**CITY OF FORT COLLINS
BID #5684
TRAFFIC OPERATIONS FACILITY
ADDENDUM No. 2**

Description of Bid Package: Bid No. 5684, Traffic Operations Facility

**TRAFFIC
 OPERATIONS
 FACILITY**

ADDENDUM # 2

AD-1

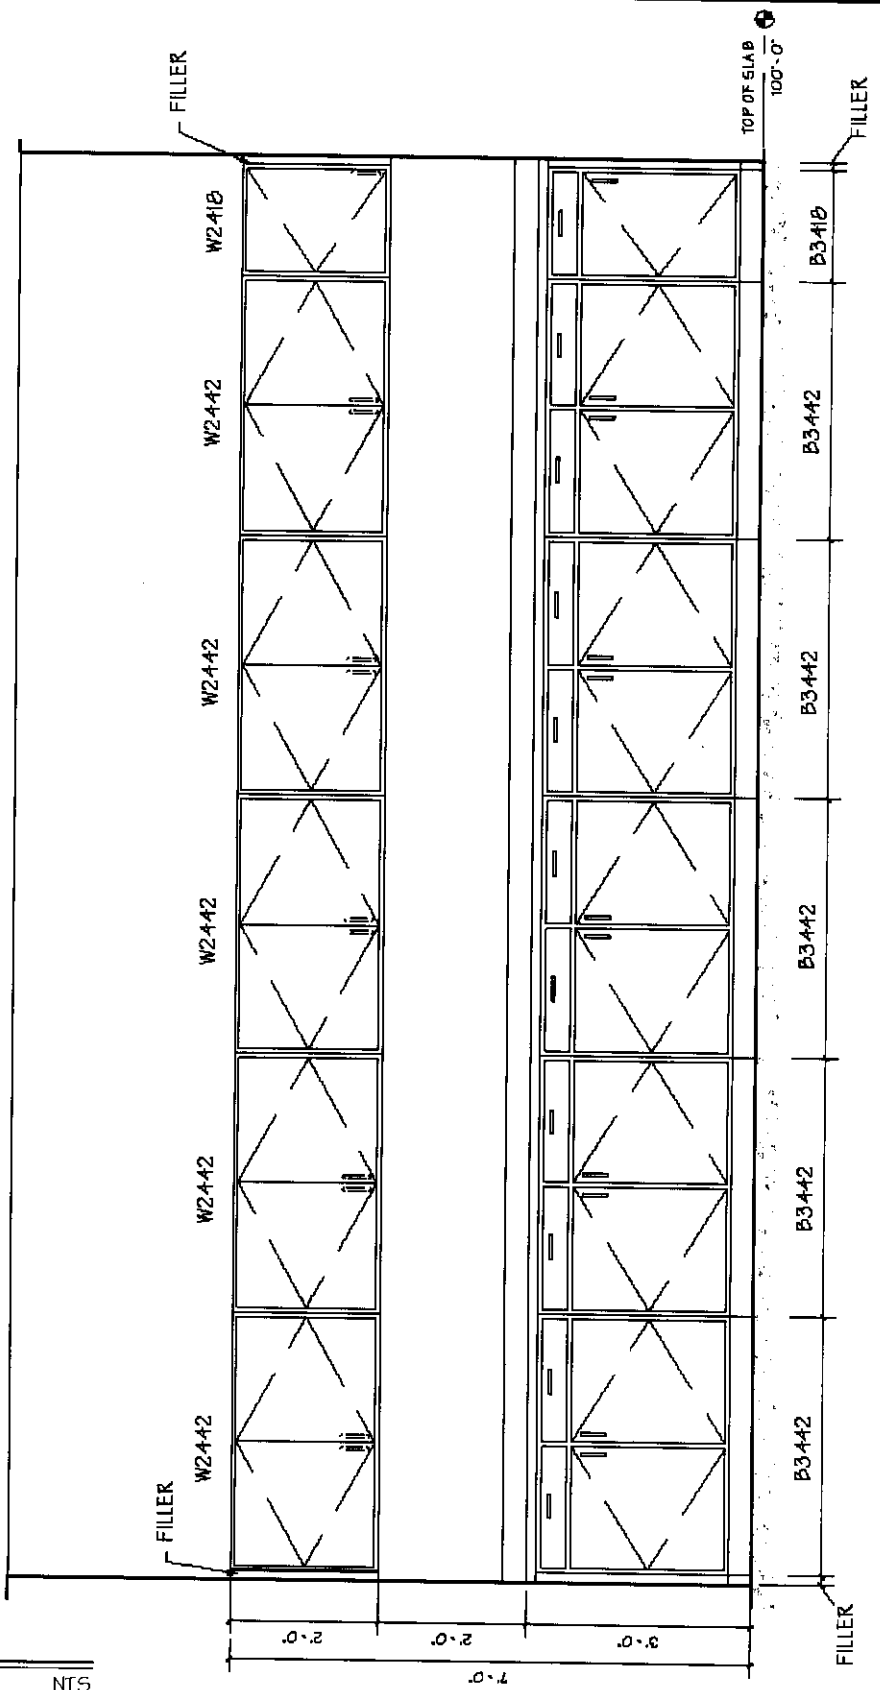
a.) Add base and upper cabinets to north wall of Work Area 111. Raise all electrical outlets to above counter height. Refer to details on attached sheet AD-1.

8 WINDOW SILL DETAIL

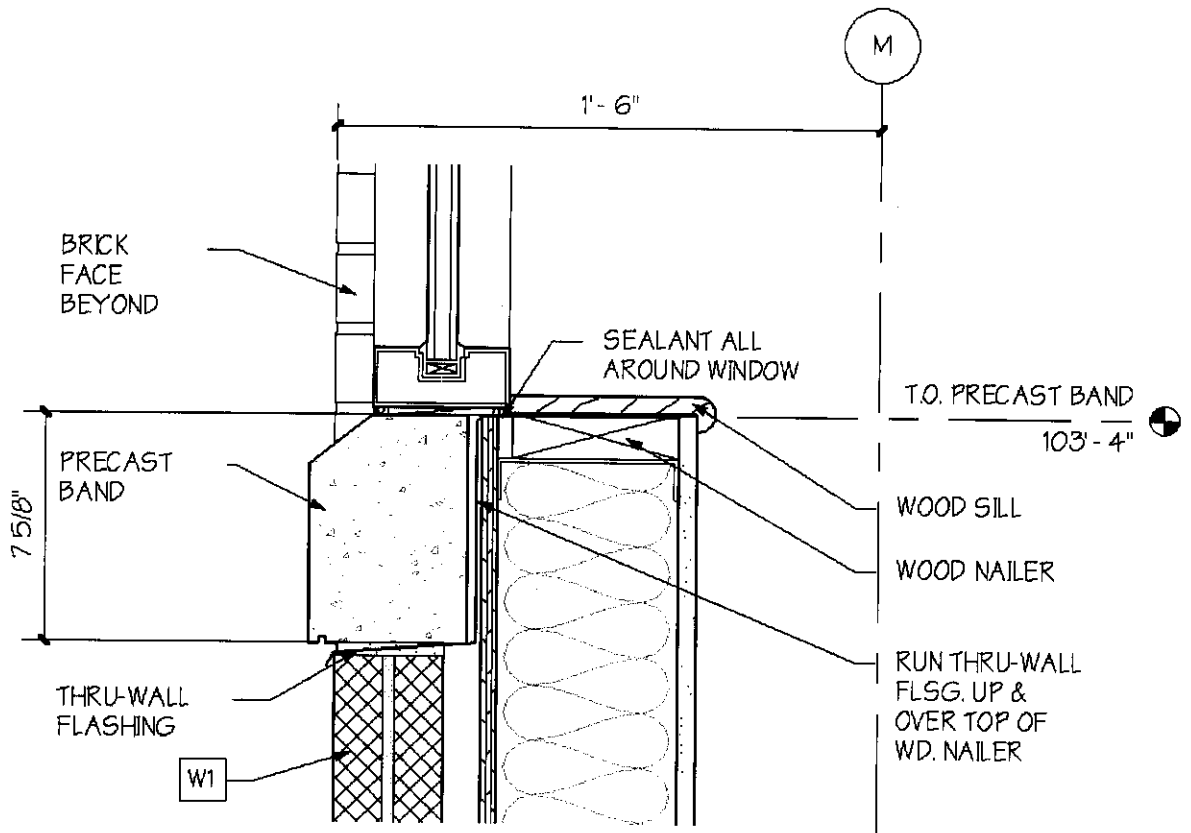
a.) At Detail 8, modify precast window sill shape. Refer to details on attached sheet AD-2.

10. Question: Sheet A3.5, Detail 8, Should there be flashing between the window frame and the pre-cast? Storefront bidders are concerned that this may be a potential future problem area.

Answer: No flashing will be required; the profile of the sill is not shown correctly; this will be clarified through the shop drawing process.

PRECAST WINDOW SILL

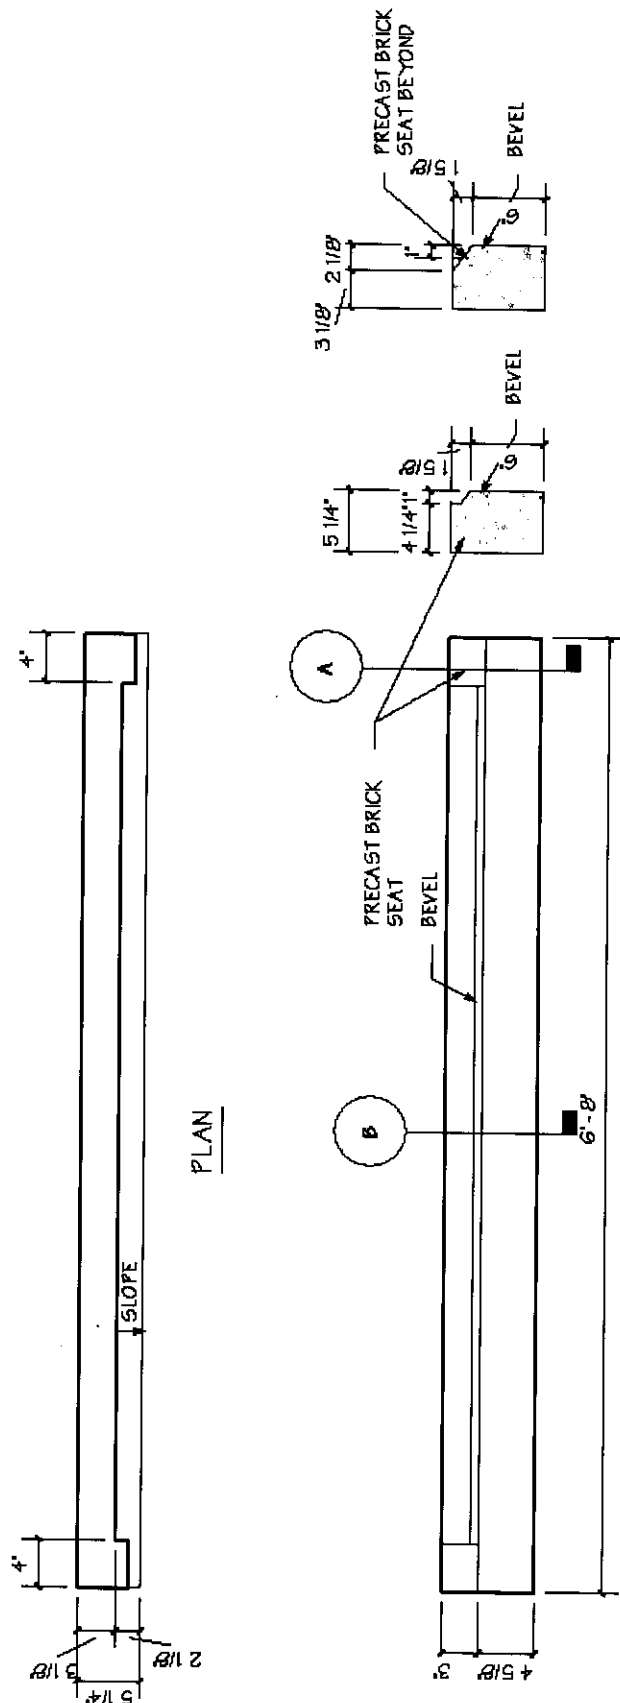
b.) Add precast window sill details. Refer to attached sheets AD-3 and AD-4.

ADDENDUM # 2		AD-5
Project number	2001-59	
Date	03/11/02	
Ref. Sheet #	A3.5	
Checked by	JR	
Scale 1 1/2" = 1'-0"

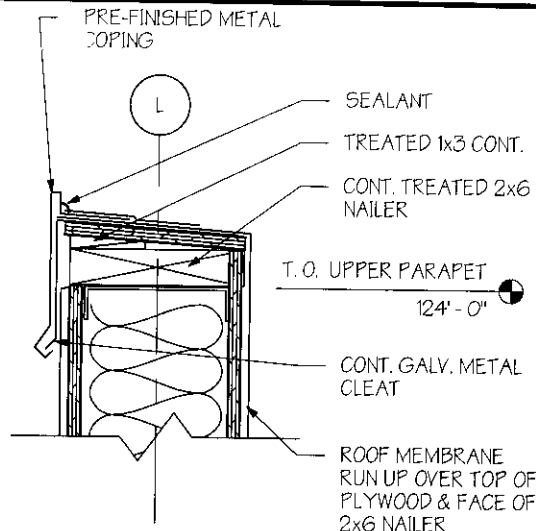
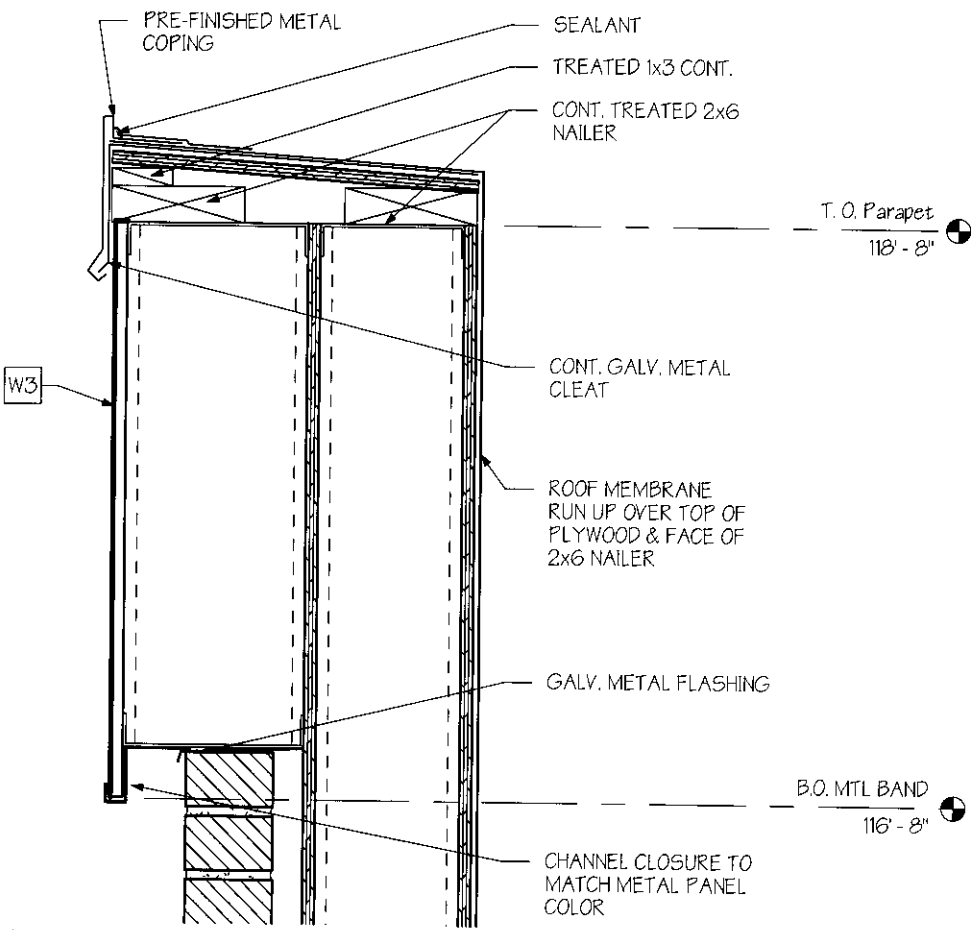
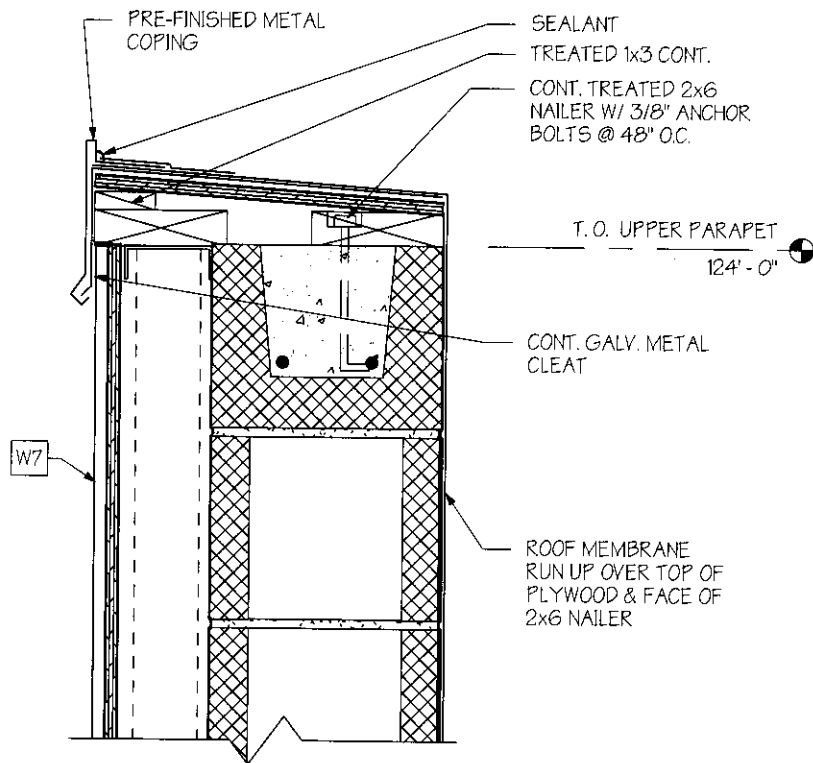
c.) Add typical wall parapet details, for clarification. Refer to attached sheets AD-5, AD-6 and AD-7.

AD-8

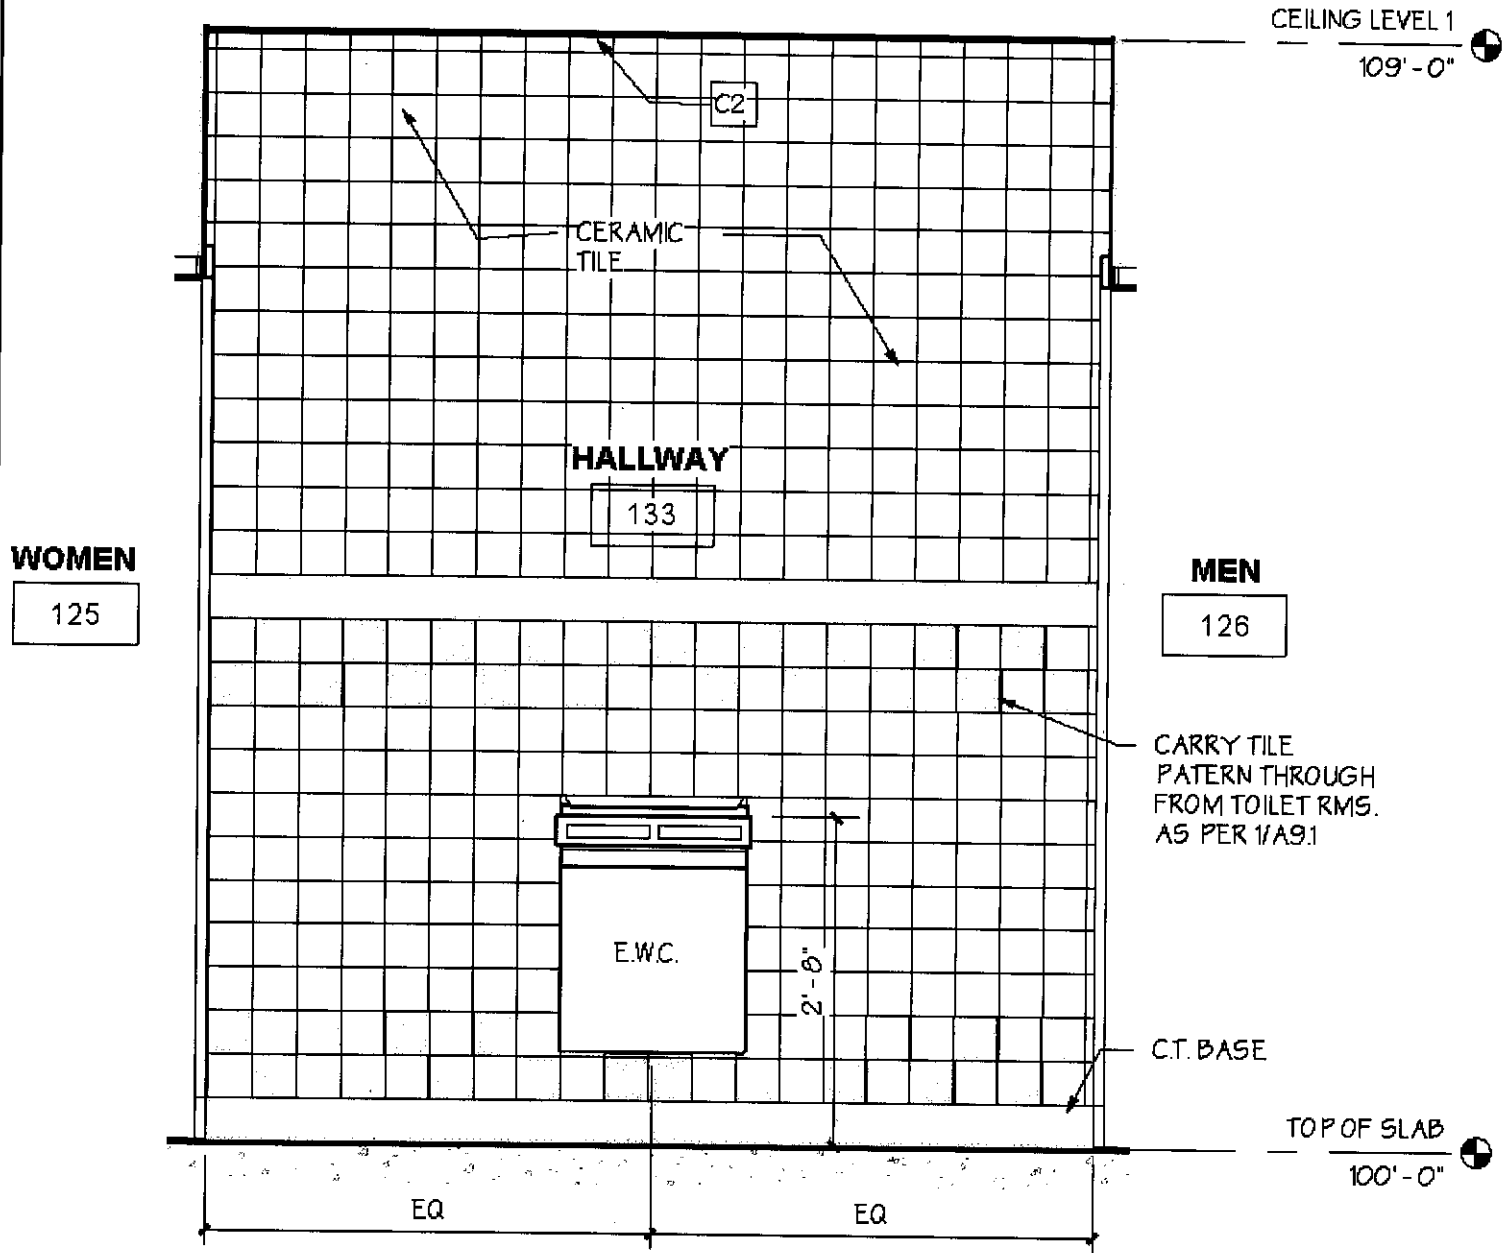
5. SHEET A6.1:
 - a.) Modify Break Room 121 cabinets, at Detail 1. Add 20 Amp. Outlet for microwave, at proper height. Refer to attached sheet AD-8.
 - b.) Delete workstations, as shown on Details 2 and 4.
 - c.) At Detail 3, carry ceramic wall tile pattern through from Toilet Rooms, as per Detail 1/A9.1. Refer to attached sheet AD-9.
 - d.) See attached sheet AD-10 for dimensioned and noted Plan of Reception Desk.
6. SHEET A8.1:
 - a.) Modify Detail 6, ENTRY COLUMN DETAILS. Refer to attached sheet AD-11.
 - b.) Make minor modifications to Detail 7, ENTRY CANOPY DETAIL. Refer to attached sheet AD-12.
7. SHEET S2.2:
 - a.) Change Detail 9/S2.2 as shown on attached sheet AD-13.
8. SHEET C5:
 - a.) Modify this sheet with the Change shown on attached sheet CD-1.

AD-14

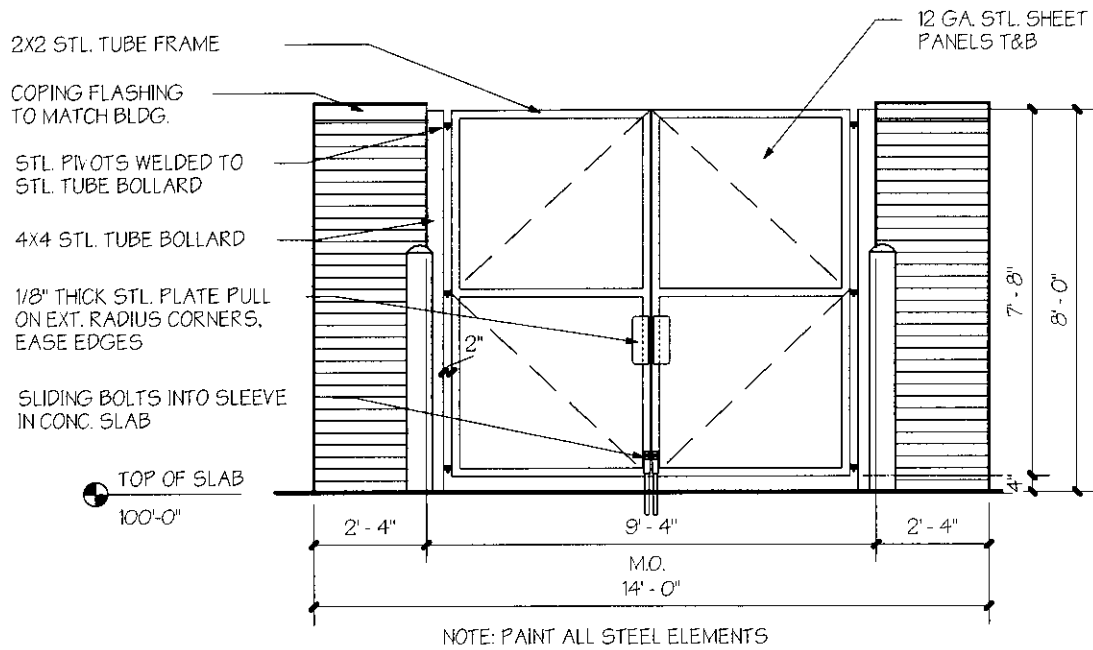
10. Question: Please clarify the construction of the "painted steel gate" in 3/AS.2. Requirements not indicated in detail or 05500.

Answer: The construction is clarified by attached sheet AD-14.
